Re: 339 West Gorham Street: Oliv Madison

Attached is a minor amendment packet for the Oliv Madison Project. These changes address some program elements (expanded amenity), design refinements, and adding solar to the project. The packet illustrates the changes between the Original SIP document and the proposed amendments. The site plan review/building permit set elevations are also included for reference to show what was approved with the building permit.

UDC MINOR REVISIONS

OLIV MADISON 339 W GORHAM STREET

RED - ITEMS PROPOSED FOR MINOR AMENDMENT
BLUE - PREVIOUSLY PERMIT APPROVED CHANGES

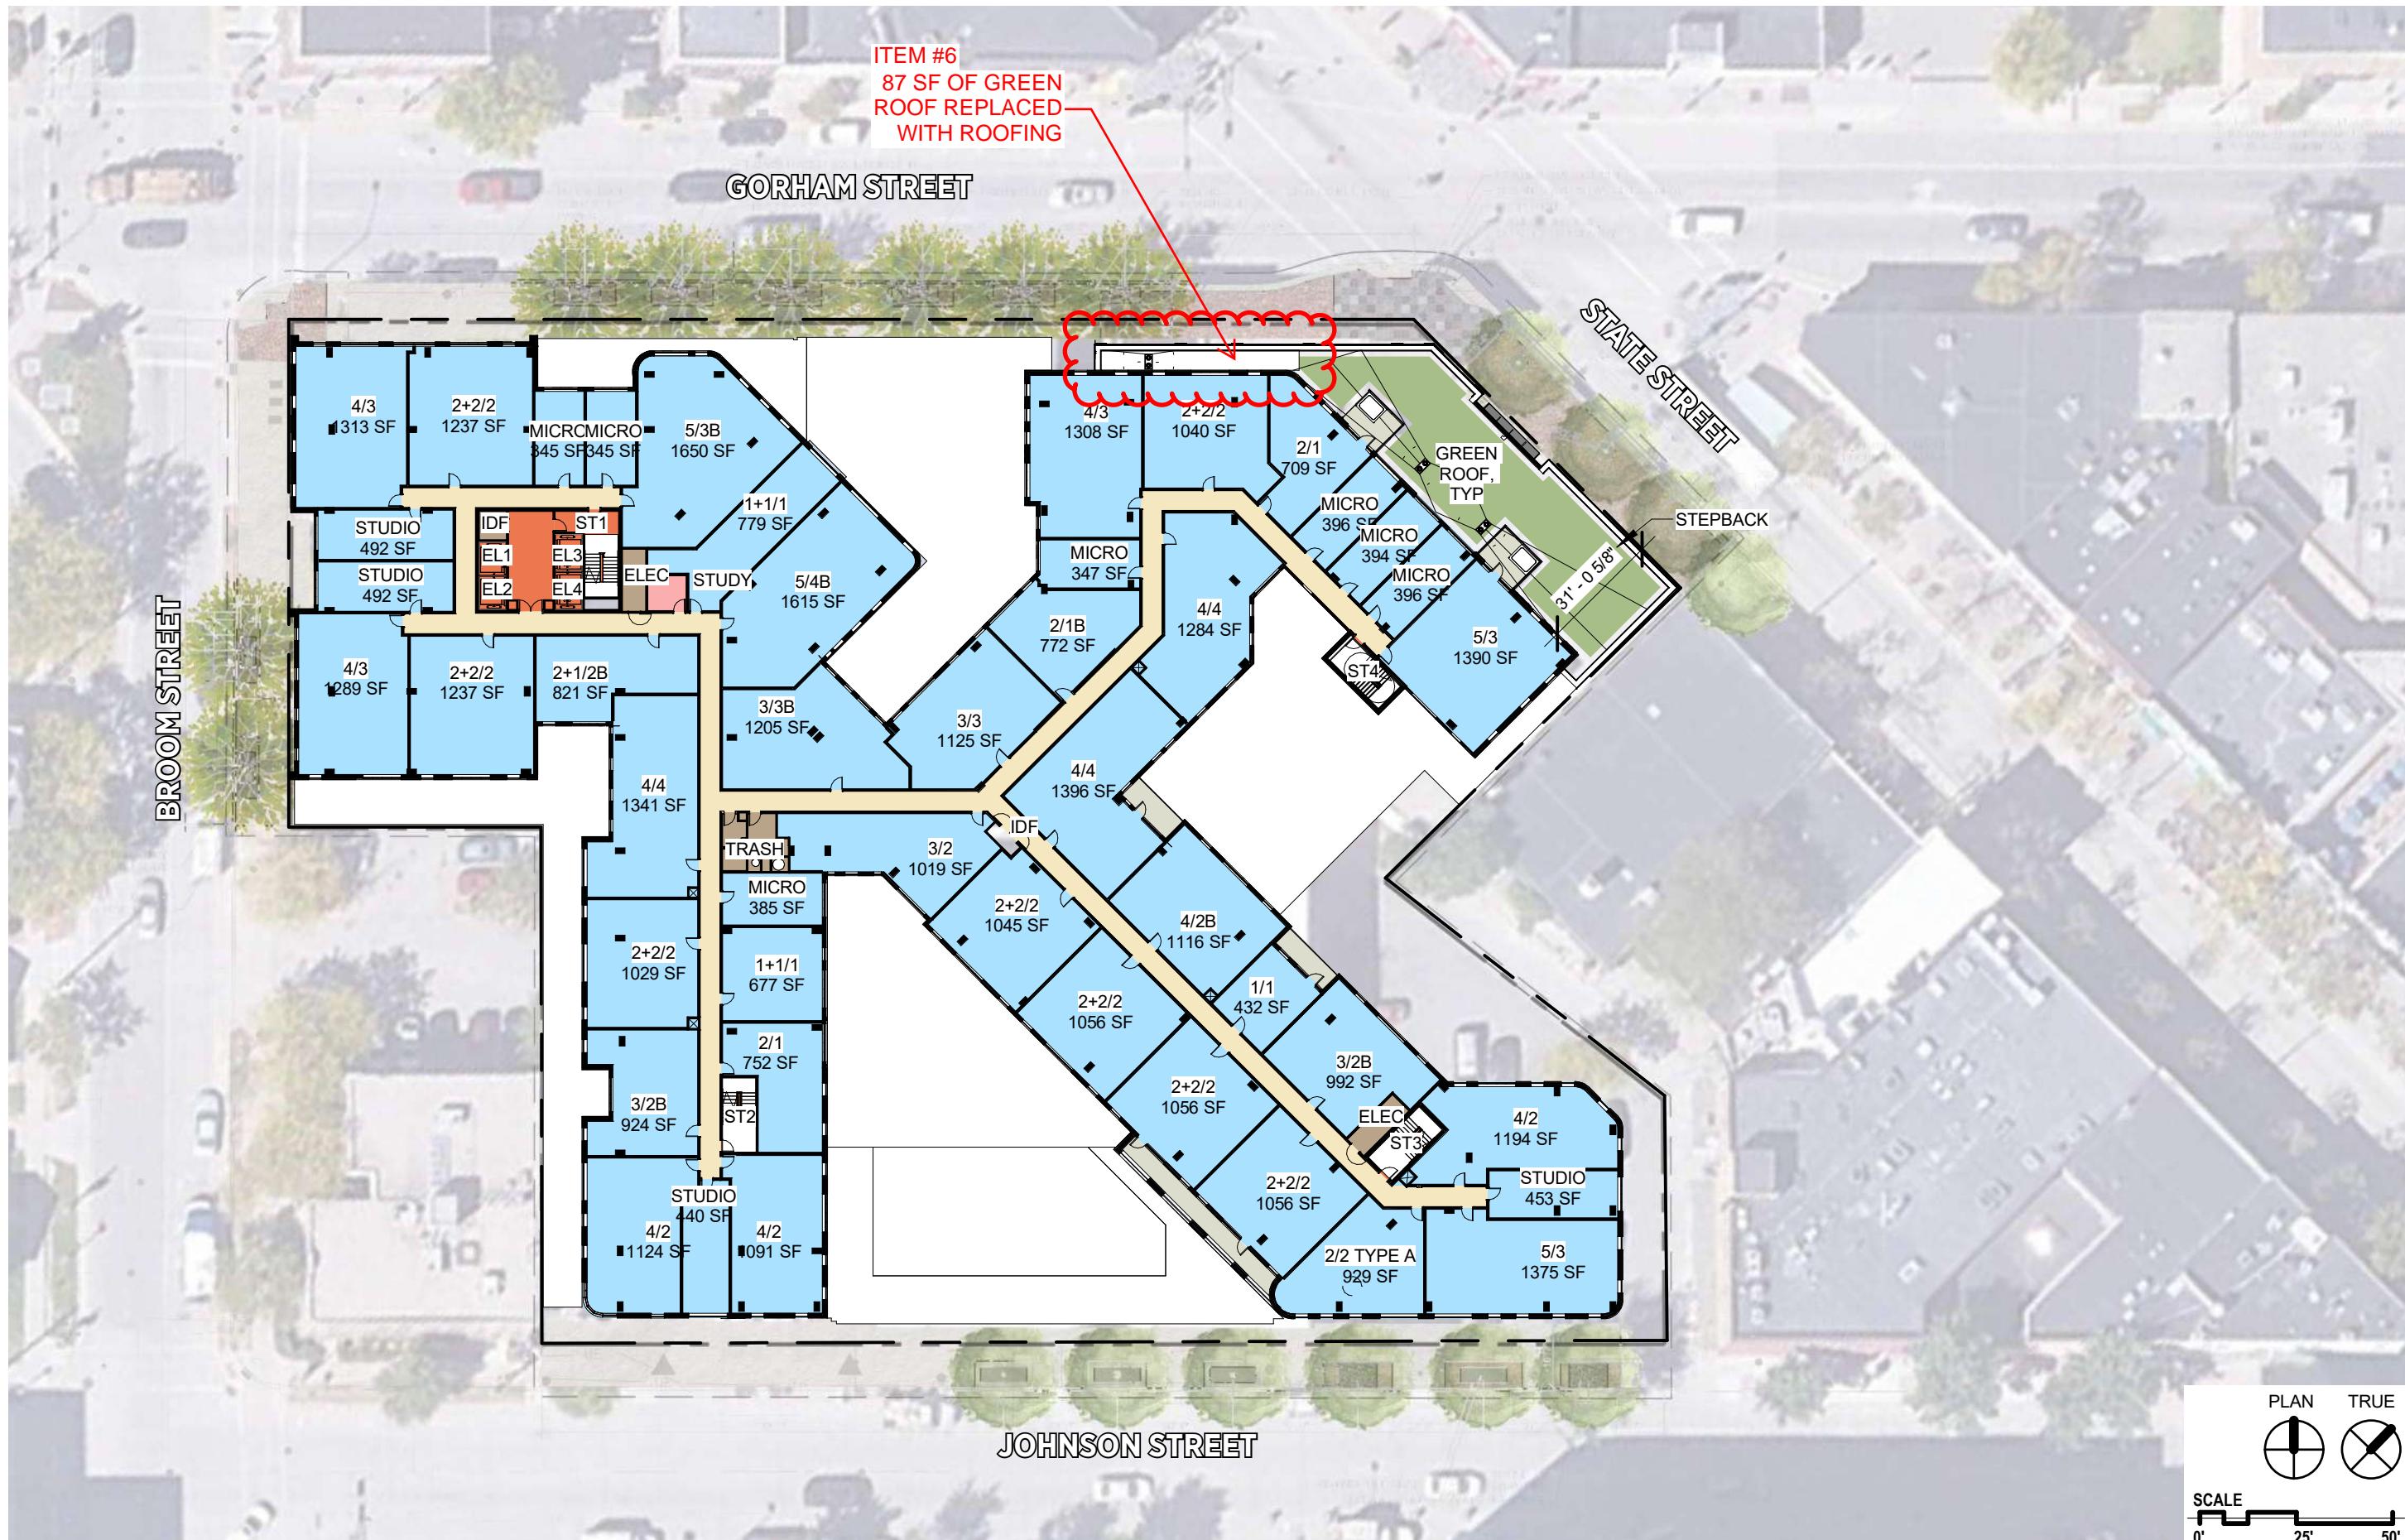
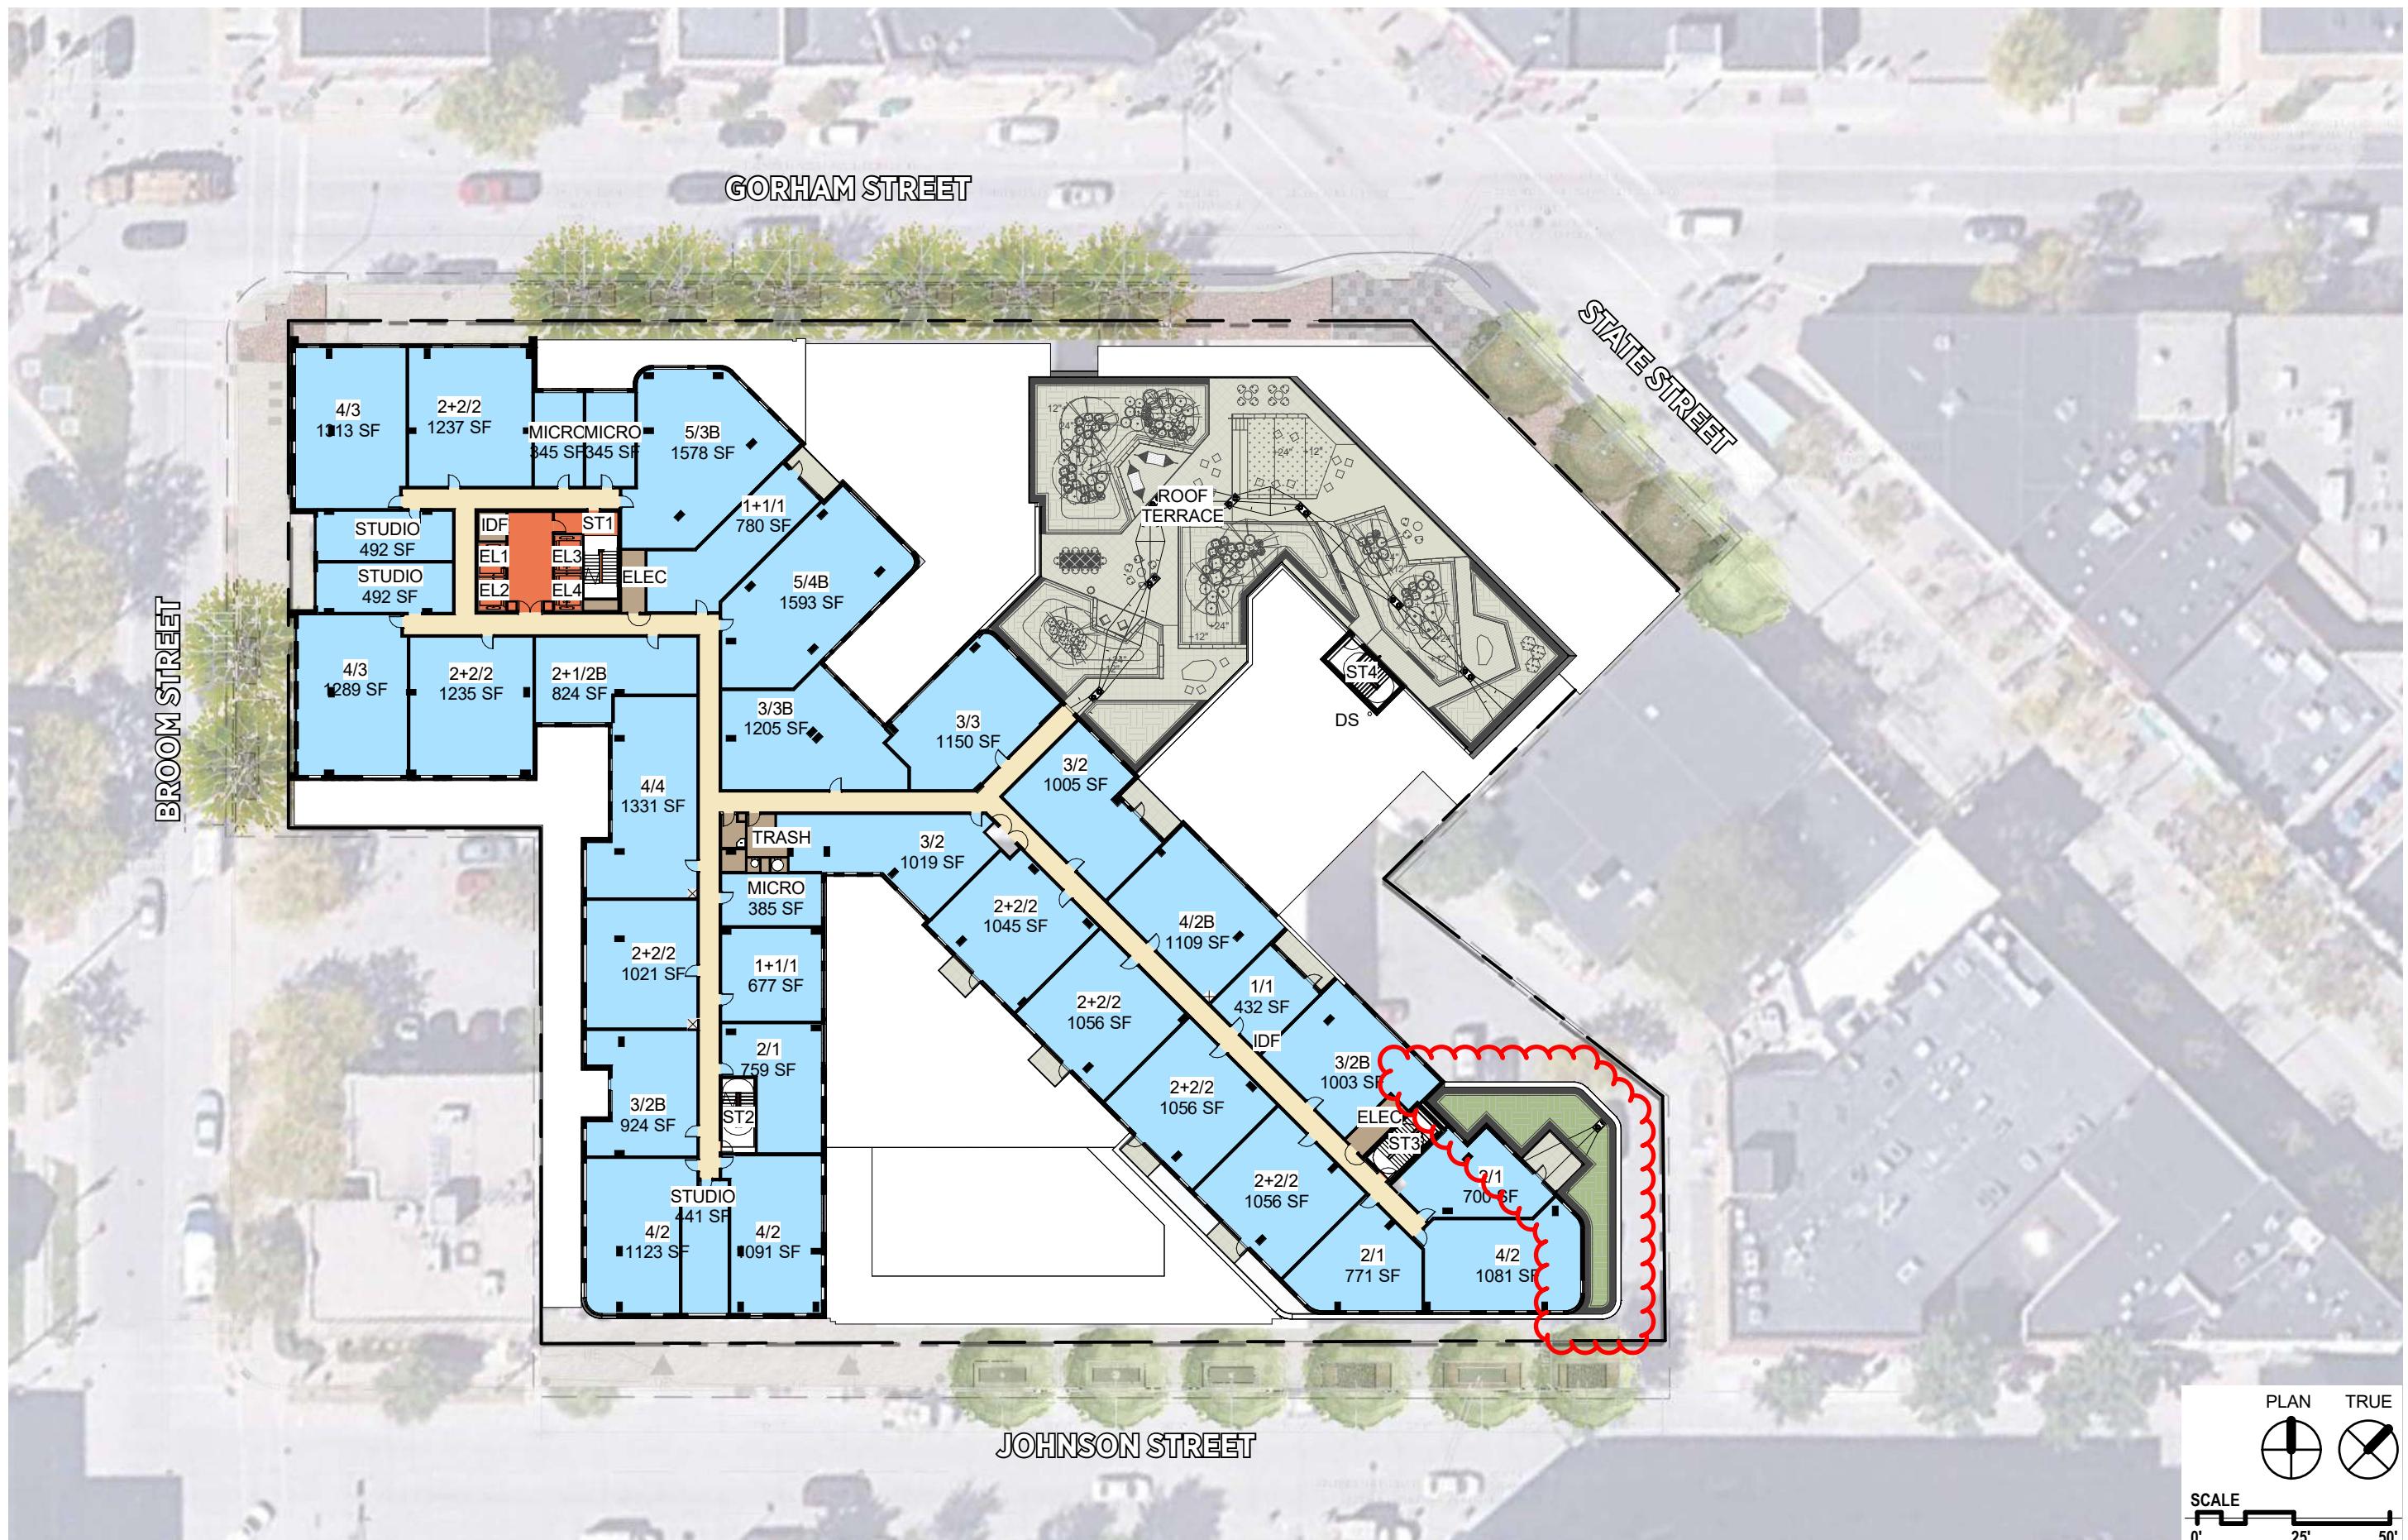
- Item 6. Added Solar Panels and green roof modifications (A45, A46, A47, A49, A51): Reduction of select green roofs for proper maintenance access. The areas deleted required maintenance access through tenant units. The removal of these select green roofs provides the financial ability to add solar panels on the roof. The project added 8,485 SF to dedicate to solar panels.

- i. Note on item 6: The project will still almost double the minimum green roof requirement for stormwater management. 6,600 SF was required. 14,209 SF was provided in approved set. The current proposal includes 11,613 SF of green roof.
